R. E. GINNA NUCLEAR POWER PLANT

AMENDMENT TO PROVISIONAL OPERATING LICENSE

Amendment No. 38
License No. DPR-18

TECHNICAL EVALUATION OF THE PROPOSED DESIGN
MODIFICATIONS AND TECHNICAL SPECIFICATION
CHANGES FOR THE R. E. GINNA NUCLEAR POWER PLANT,
UNIT 1

FIG. 2.3-1

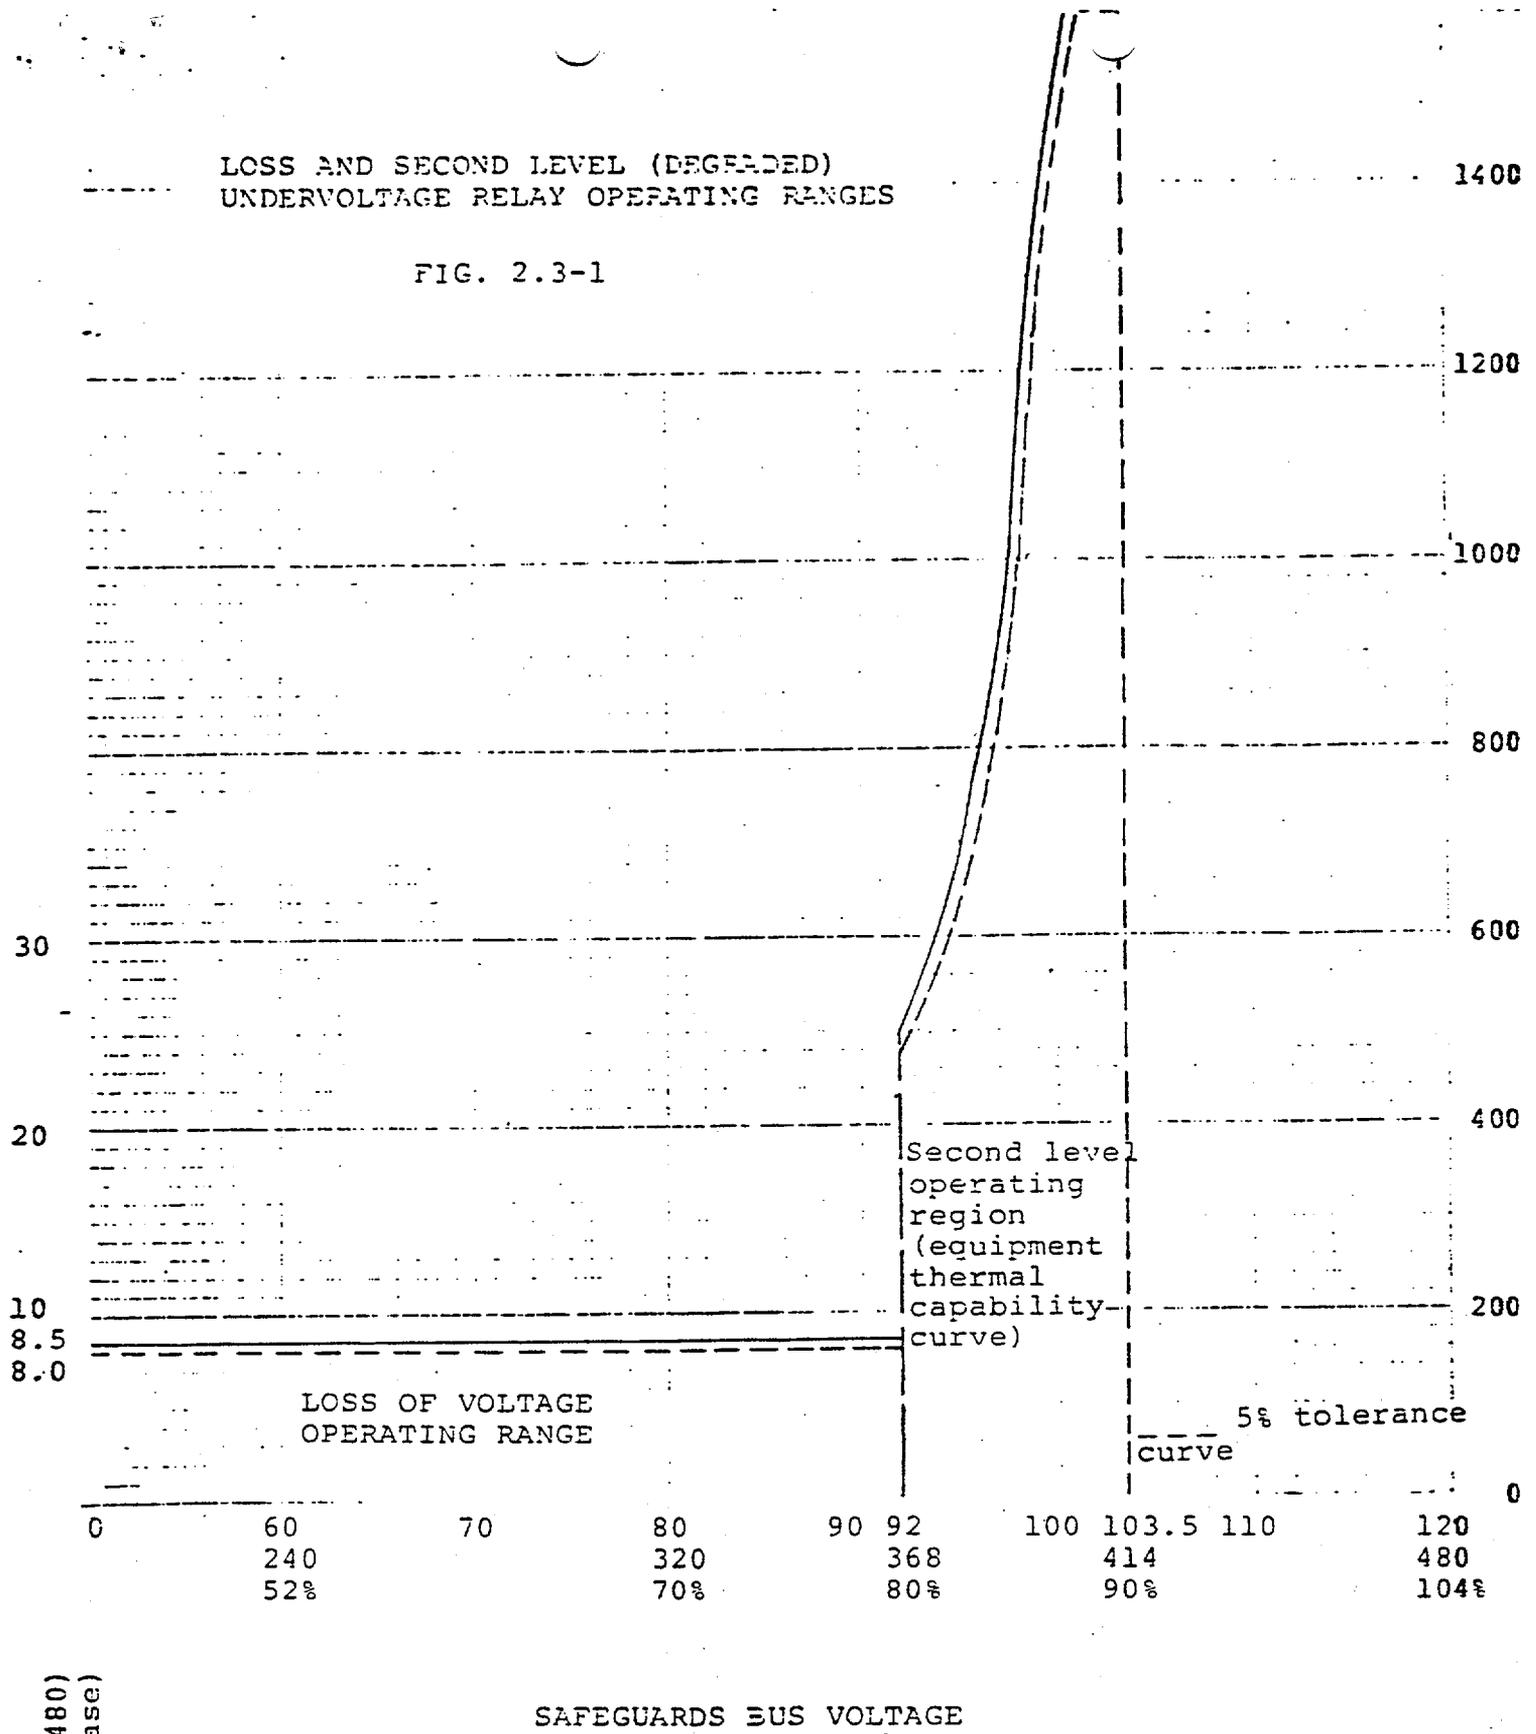
2.3.3.1 Loss of voltage relay operating time \leq 8.5 seconds for 480 volt safeguards bus voltages \leq 368 volts.

Measured values shall fall at least 5% below the theoretical limit. This 5% margin is shown as the 5% tolerance curve in Figure 2.3-1.

2.3.3.2 Acceptable degraded voltage relay operating times and setpoints, for 480 volt safeguards bus voltages \leq 414 volts and $>$ 368 volts are defined by the safeguard equipment thermal capability curve shown in Figure 2.3-1. Measured values shall fall at least 5% below the theoretical limit. This 5% margin is shown as the 5% tolerance curve in Figure 2.3-1.

The 5% tolerance curve in Figure 2.3-1 and the requirements of specifications 2.3.3.1 and 2.3.3.2 include 5% allowance for measurement error. Thus, providing the measurement error is less than 5%, measured values may be directly compared to the curve. If measurement error exceeds 5%, appropriate allowance shall be made.

Figure 1. Loss-of-voltage and second-level undervoltage relay operating ranges.

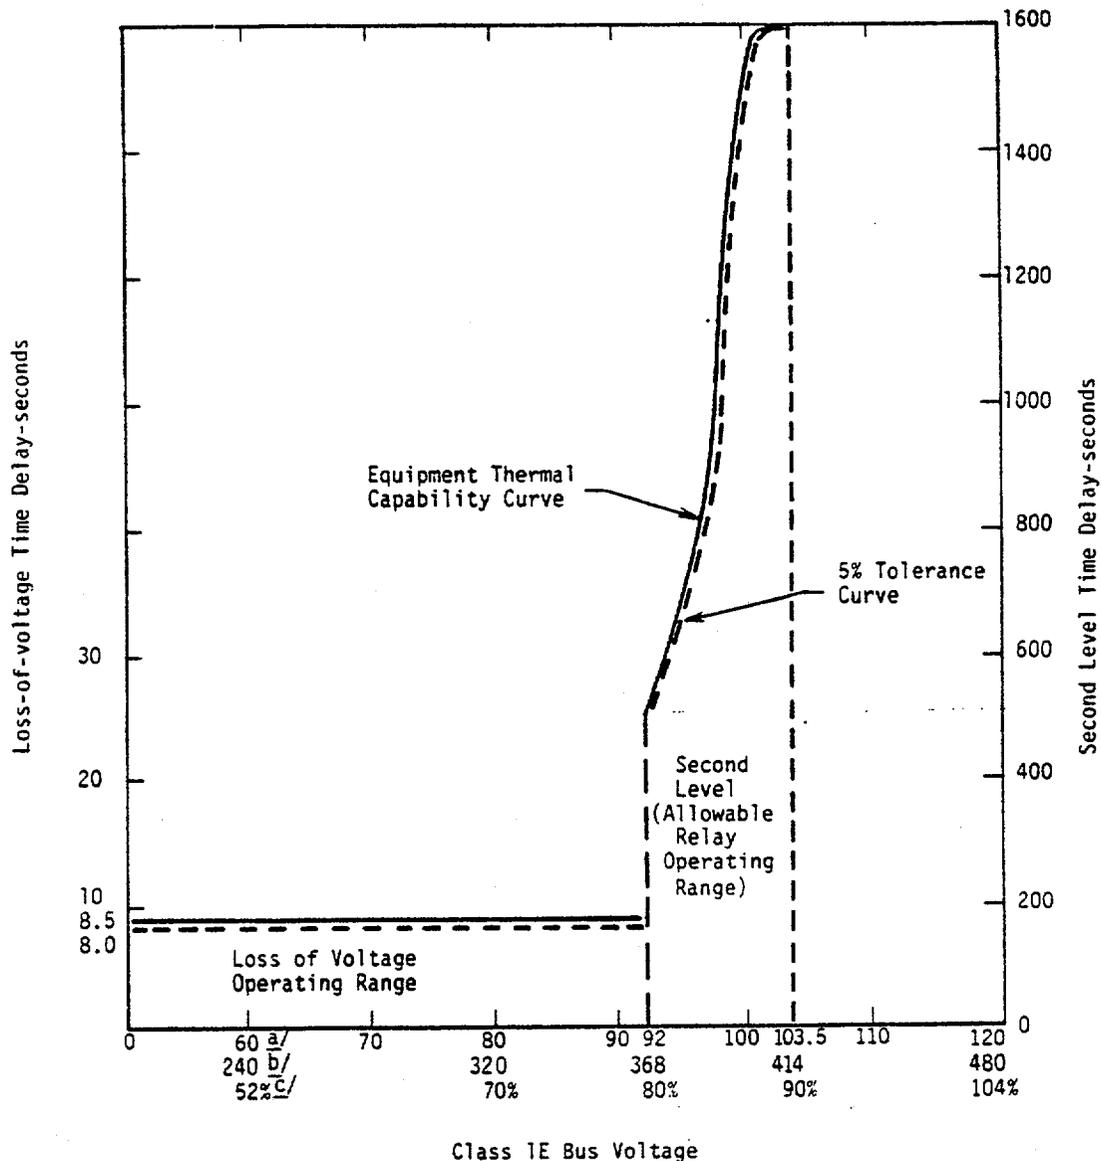
The licensee's second level of undervoltage protection setpoints (voltage and time delay) are defined by the curves shown in Figure 1. The solid-line curve defines the maximum time (determined by equipment manufacturers) that the Class 1E equipment can operate for a specific degraded voltage without causing equipment damage, loss of equipment life, or affecting the ability of the equipment to perform a required function. The maximum time delay at the 414-volt setpoint is 1600 seconds. The dotted-line curve (5% tolerance band) defines the maximum allowable time delay before protective relaying actuation is initiated. This tolerance band was determined by all the accuracies of the relay test instrumentation. The relays will be tested to insure that they perform according to their design operating characteristics, which must fall within the area defined by the dotted-line curve in Figure 1.

Any deviation outside the limits defined in Figure 1 will result in recalibration of the relay. The licensee's analysis has been reviewed and shows that this protection range is satisfactory for the 480-volt Class 1E loads and other components whose functional performance would be inadequate because of undervoltage.

The second-level undervoltage relay setpoints defined in Figure 1 are such that the relay operating characteristics will protect the Class 1E equipment from sustained degraded voltage and also insure that all Class 1E motors will start successfully and be loaded onto the diesel generator within the time assumed in the FSAR accident analysis.

The licensee's proposed time delay defined in Figure 1 is long enough to override any short grid disturbances.

Figure 2. Coincident trip logic for bus 14.

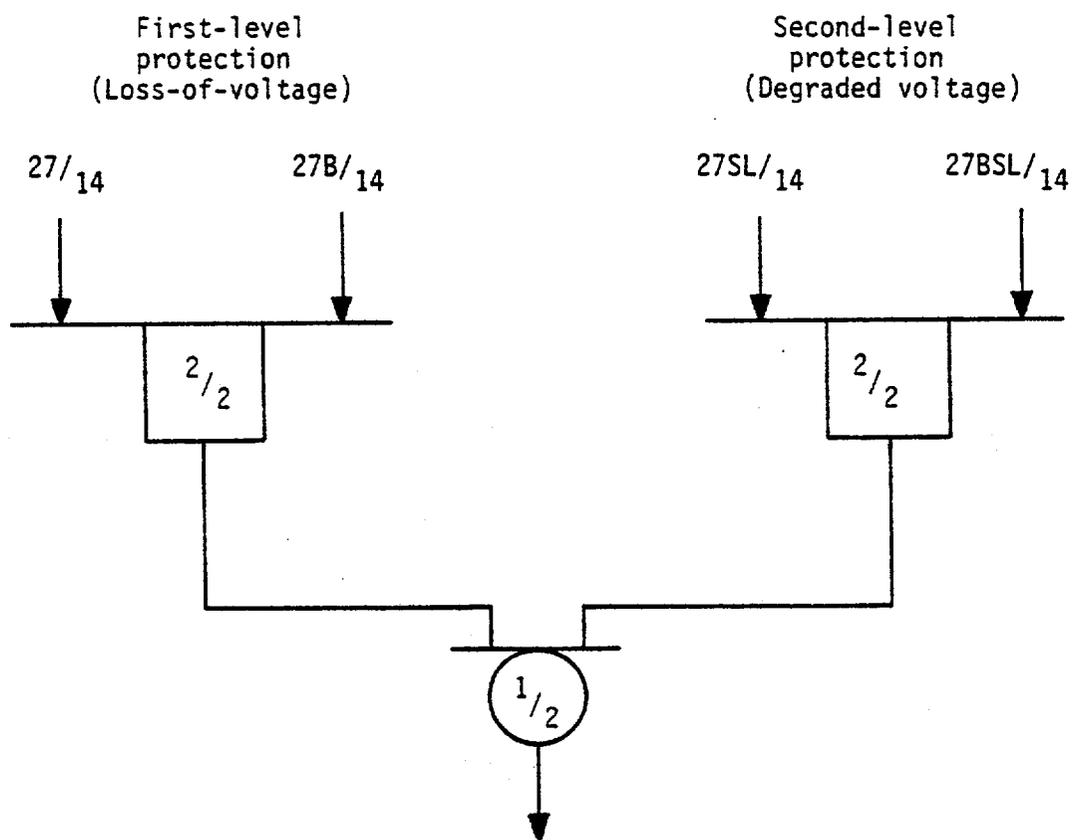
The second-level protection scheme will be designed using two-out-of-two coincident logic. The integration of the second-level protection system into the first level of undervoltage protection can be seen in Figure 2. If a loss-of-voltage condition exists, relays 27 and 27B will drop out and initiate the automatic voltage-restoring scheme. For a degraded voltage condition, relays 27SL and 27BSL will drop out after the time-delay setpoints are exceeded and will initiate the automatic voltage-restoring scheme.

The two-out-of-two coincidence logic automatically disconnects offsite power from the Class 1E buses experiencing degraded voltage and initiates the voltage-restoring scheme.
